Meeting:	Development Management Committee
Date:	Wednesday 6 <sup>th</sup> June 2007
Subject:	4 Aylwards Rise, Stanmore
Responsible Officer:	Director of Planning Services
Contact Officer:	Graham Jones
Portfolio Holder:	Planning, Development and Enterprise
Enclosures:	Site Plan
Key Decision:	No
Status	Part I
Ward	Stanmore Park

This report relates to the erection of a detached dwellinghouse and detached garage within the curtilage of land at 4 Aylwards Rise, Stanmore ("the Site") and considers the expediency of taking enforcement action.

## **Appendix 3 – Report of DPDS Consulting Group dated 16<sup>th</sup> May 2007**

**Appendix 1 – 1:500 scale aerial photograph of the Site from 2001**

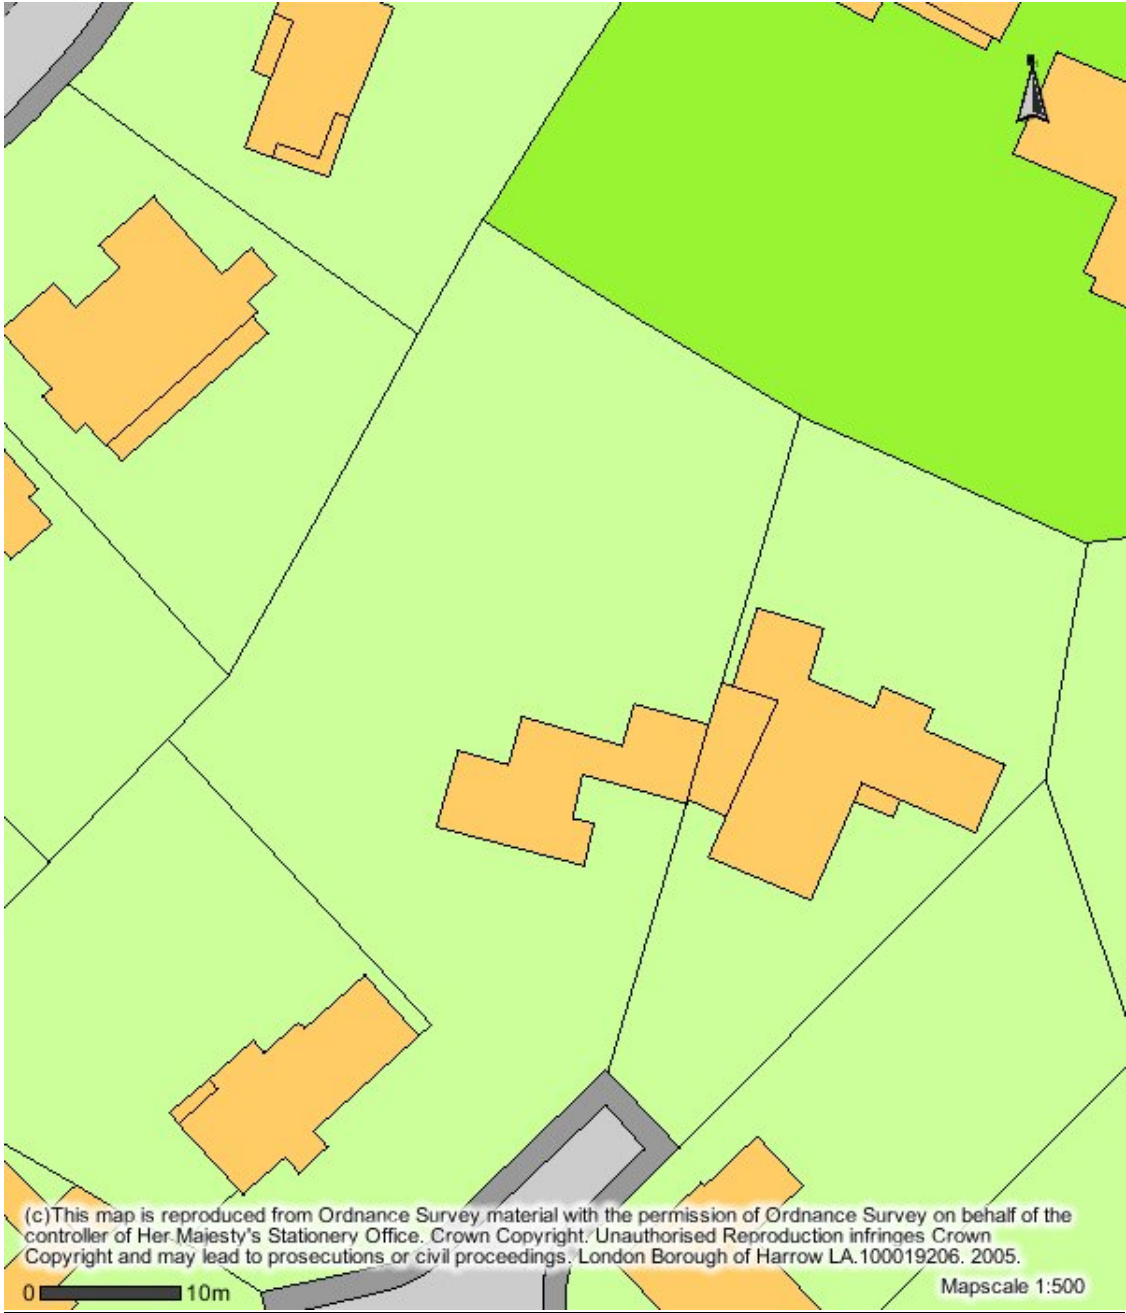
The measurement obtained from this source shows the original dwelling front elevation at its north west corner, measured at right angles to the main wall, as 11.47m. I have checked the submitted plans along with the 1:500 scale aerial photograph supplied by the Council and have concluded, as did Council officers when notified of the alleged breach, that it would appear that the original dwelling house was never actually sited as depicted on the Ordnance Survey plan at a distance (as measured above) of 11.5m but, as confirmed by the aerial photograph (allowing for circa. 200mm eaves projection from the main wall) at about 9.4-10m. A further check measurement was taken along the eastern boundary of No. 4 Aylwards Rise picking up the projected line of the new property to the back of footpath in the highway. This measured 13.20m on site. This distance scales approximately 13.0m from the aerial photograph of 2001 showing the original dwelling which, allowing for the projecting eaves overhang of circa. 200mm, would suggest that this building line is in line with the original. It is impossible to be absolutely precise with such an exercise but both on-site checks provide reasonably accurate evidence. The approved plan indicates a distance at this point of 13.9m and the Ordnance Survey plan 13.75m.
